**Technical Note
e-Notification**

No. 04
October 29, 2019

Technical Note 04

1. Labeling Diagram Guidance

Figure A5.3-2. Girder Plan View Labeling Convention

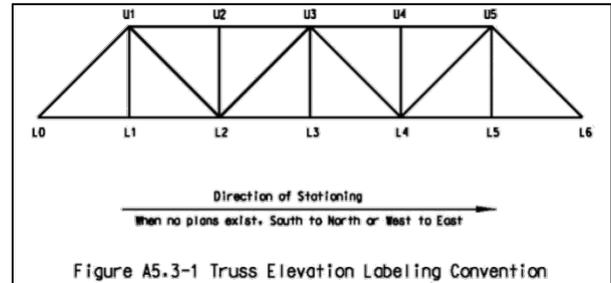
5. Number each superstructure component (e.g. beams) left to right in direction of stationing in each span. When components are added adjacent to existing (e.g. bridge widening) after the original labeling diagram and load rating creation, label new components with number of the nearest adjacent and add alpha characters to the designation. Refer to Figure A5.3-2 of this document. No alpha characters shall be utilized for bridges widened before the generation of the original labeling diagram and load rating.

- ① Original Girders from original Labeling Diagram.
- ② Additional Girders from Widened Structure after Labeling Diagram and Load Rating creation.

Figure A5.3-4. Standard Pile Labeling Convention

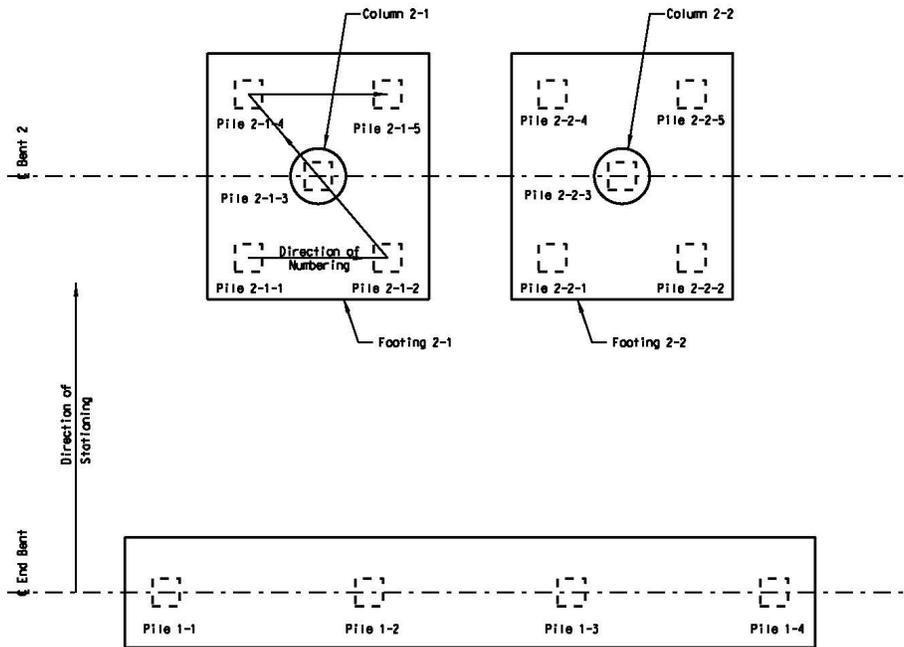
4. Page 5-11, second paragraph is revised to read: *“Each pile in a substructure shall have a unique number assigned to it. Pile numbers shall be assigned in the direction of the stationing from left to right. For pile bents, the pile designations are composed of two parts: the first label corresponds to the bent number and the second label corresponds to the pile number. For pile footings, the pile designations are composed of three parts: the first label corresponds to the bent number, the second label is the footing number and the third label is the pile number within the substructure component. When piles are added adjacent to the existing piles, as in the case of a bridge widening after the original labeling diagram and load rating creation, label new piles with new numbers, and add an alpha character to the designation of the new pile. Refer to Figures A5.3-4 through A5.3-5 of this document. For piles within a pile bent that are added after the original labeling diagram and load rating creation, refer to Figure A5.3-6.”*

Figure A5.3-6. Standard Pile Labeling Convention

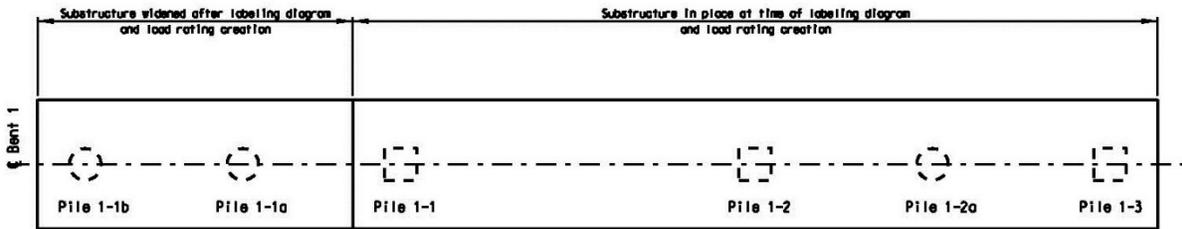
Pile 1-2a added after labeling diagram and load rating creation.

Figure 1 - Labeling defined for current SCDOT load rating contract which includes any widening already constructed

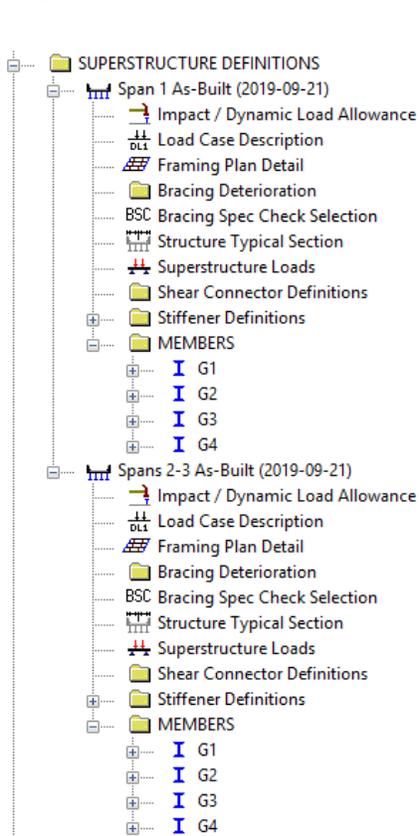
How do the labeling diagram, AASHTOWare BrR, and the Load Rating Summary Sheet correlate to bridge widenings? For example, labeling diagrams have Girders 1A and Girder 1, but I believe AASHTOWare BrR starts with the left most girder as Girder 1 and increases sequentially and this is how it is shown in the Load Rating Summary Form (LRSF).

Labeling diagrams, as they pertain to bridge widenings, shall be labeled as outlined in the guidelines provided in this Technical Note. As described, added girders to widened structures that are widened after the original labeling diagram and load rating creation will carry an alpha designation.

There is some ambiguity that arises when attempting to strictly follow the girder naming convention as outlined in LRGD Appendix A5.3 for continuous span superstructure definitions and linked superstructure definitions in BrR. Rather than applying the LRGD convention of "Girder [span]-[number]" in BrR, load raters should use the basic naming convention of "G[number]" in BrR, where [number] corresponds to the member number within the cross-section.

The span number(s) are clearly designated within the superstructure definition name in BrR (in accordance with LRGD Section 20.3.2) and therefore the span number does not need to be tied to the girder name. It

becomes intuitive as to which girder defined in the BrR model corresponds to a girder drawn in the labeling diagram. See *Figures 1 & 2* for further clarification.

Multiple Span Labeling Diagram

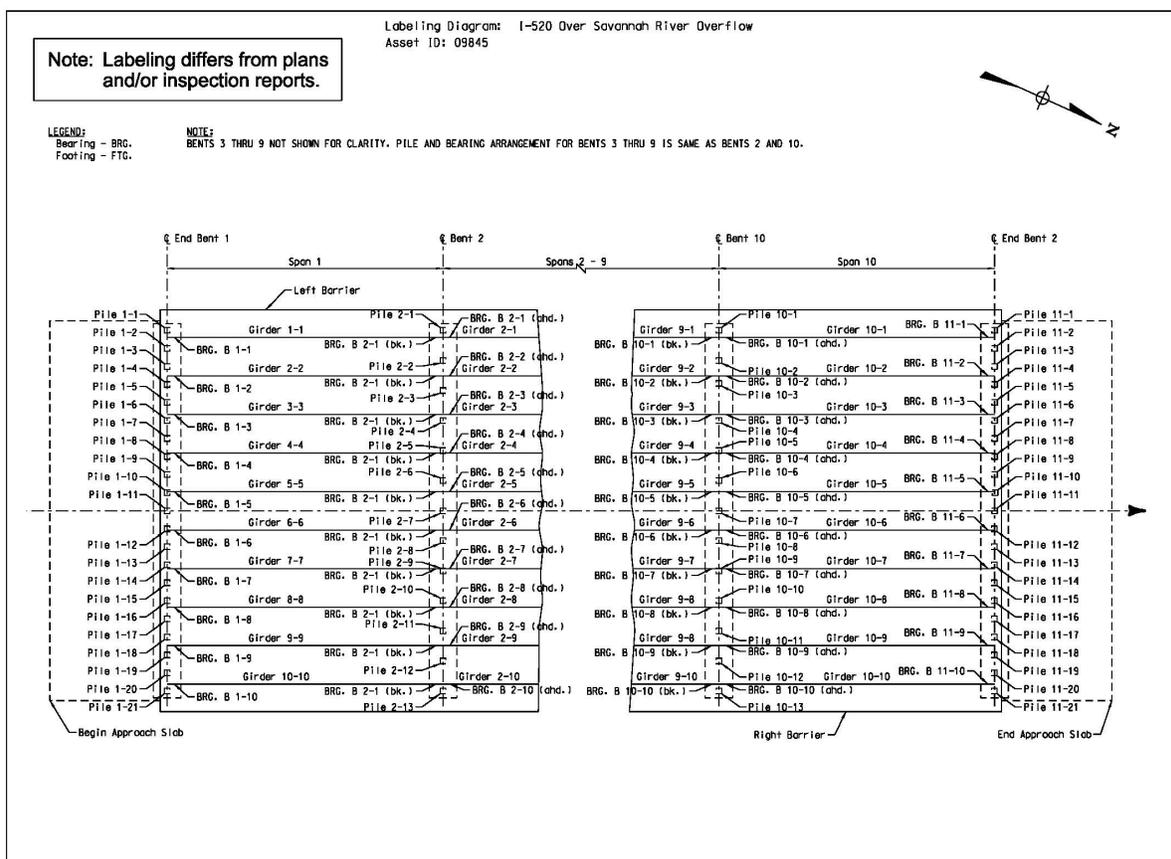
Can multiple span bridges be simplified on the labeling diagram as shown?

No exception is taken to this proposed simplified labeling diagram, except that the numbering and labeling of bridge elements should follow what is documented in Technical Note 04.
